**MALLINCKRODT  
NUCLEAR  
CORPORATION**

Plant  
Hematite, Missouri

August 16, 1960

SUBJECT: Extension of SM-33 to include a Bird Cage for  
Eight Inch Diameter UF<sub>6</sub> Cylinder

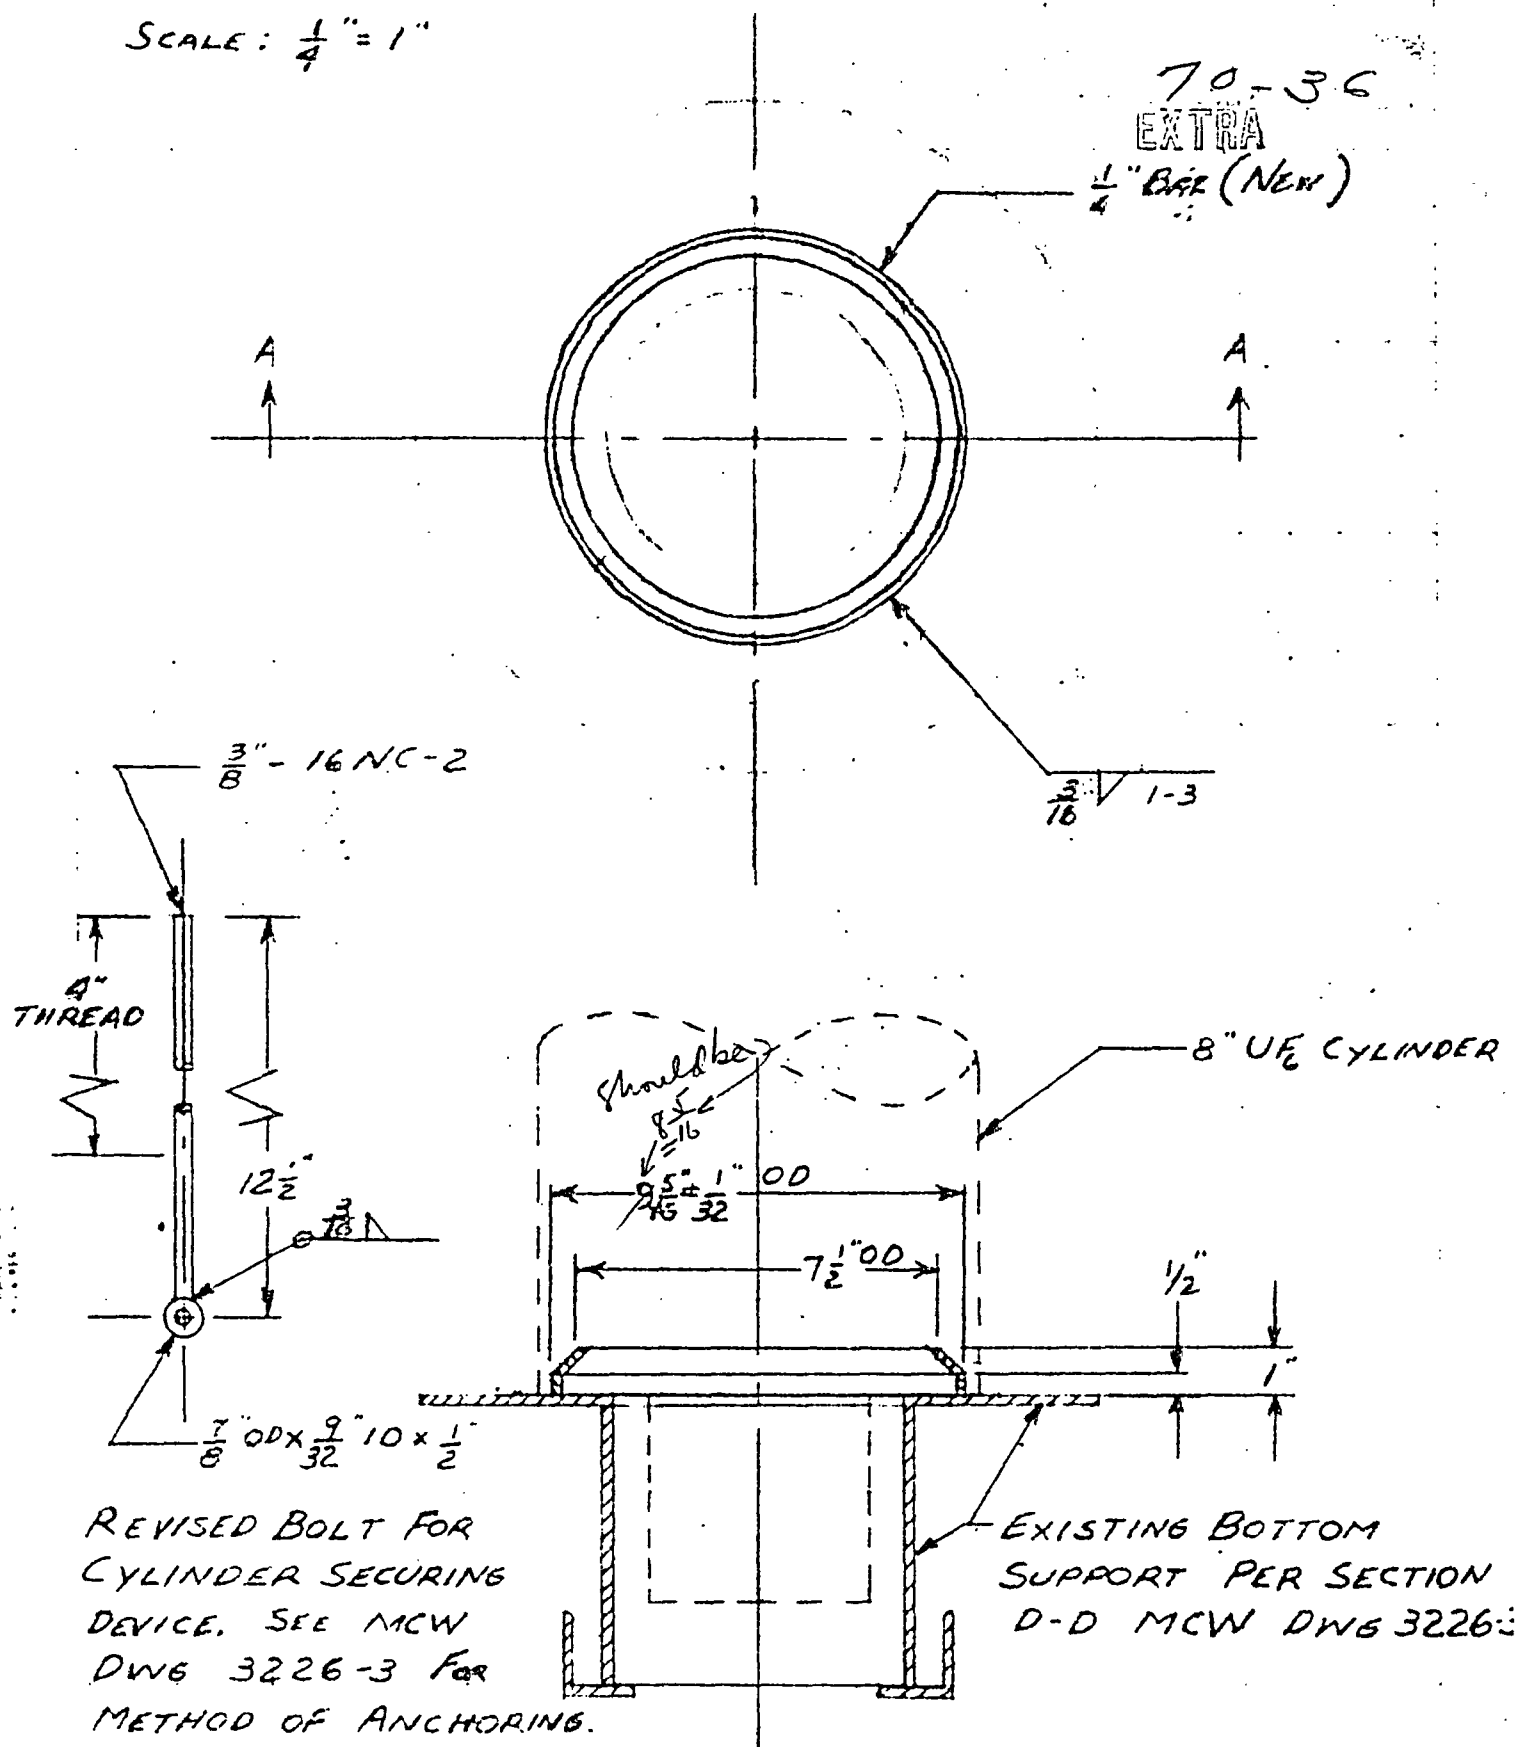
The eight inch UF<sub>6</sub> cylinder will be mounted in the bird cage with the valve end down. The valve cover will be enclosed in the bottom support as shown on SK 7-1. Lateral movement of the cylinder on the bottom support will be prevented by the 1/4" bar added to the bottom support as shown on SK 7-1.

Finally the cylinder is held down in the same manner depicted in the detail titled "Cylinder Securing Device" shown on MW 3226-3. The only modification necessary is the addition of two 12 1/2 inch long bolts as shown on SK 7-1 with their location shown on SK 7. The existing 6 1/2 inch long bolts will remain for anchoring the MD cylinders.

MOUNT NEW 12½" LONG  
BOLT FOR CYLINDER  
SECURING DEVICE PER  
DWG 3226-3

PARTIAL FRONT VIEW PER MCW

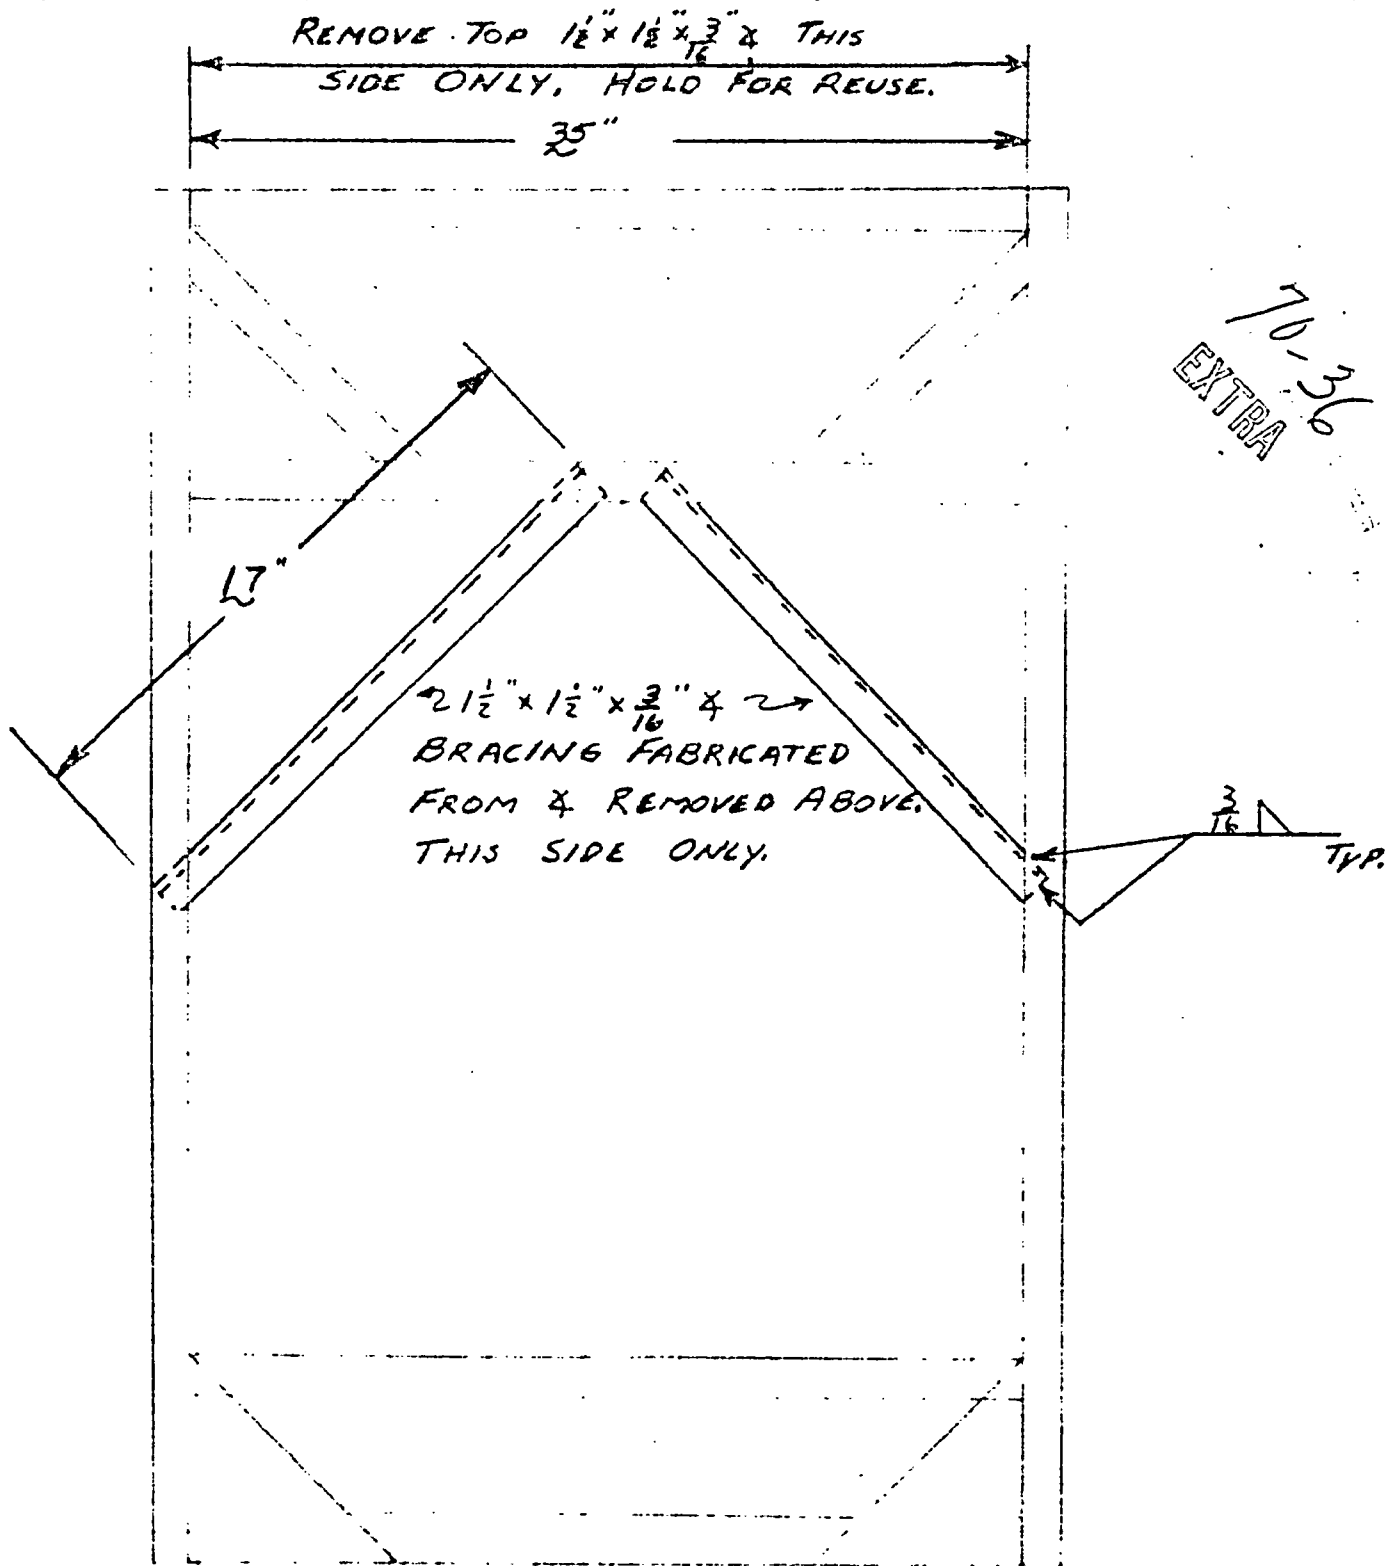
To facilitate loading and unloading the eight inch cylinder, the top angle on the front side of the bird cage will be removed. This angle will then be used as additional bracing as shown on SK 9.
